Service Bulletin

2002 GL1800 Reverse Cable Inspection/Adjustment

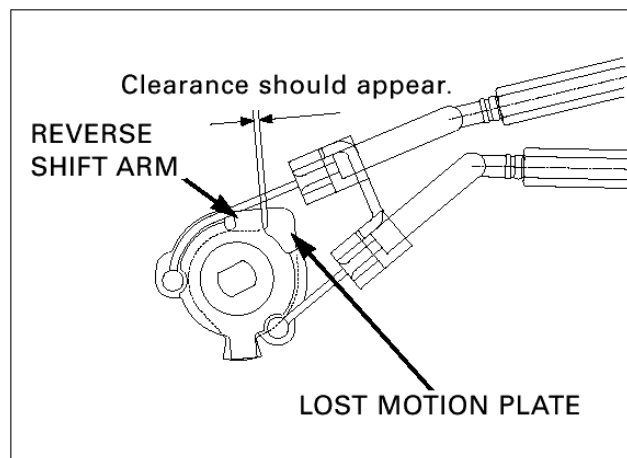
1. Remove the right engine side cover (see S/M Page 2-4).
2. Check the cable clearance on the N (neutral) and R (reverse) cables.

Note: It is not necessary to remove the center inner fairing or inspect the reverse shift actuator.

3. If adjustment is necessary, loosen the lock nuts and turn the adjusting nuts in the required direction (see S/M Page 18-35).
4. With the transmission in neutral, turn the ignition switch to the "ON" position and push the reverse shift switch to "ON".
5. Ensure there is clearance between the reverse shift arm and lost motion plate.

6. Push the reverse shift switch to "OFF" and turn off the ignition.
7. Tighten the reverse cable lock nuts.
8. Reinstall the right engine side cover.
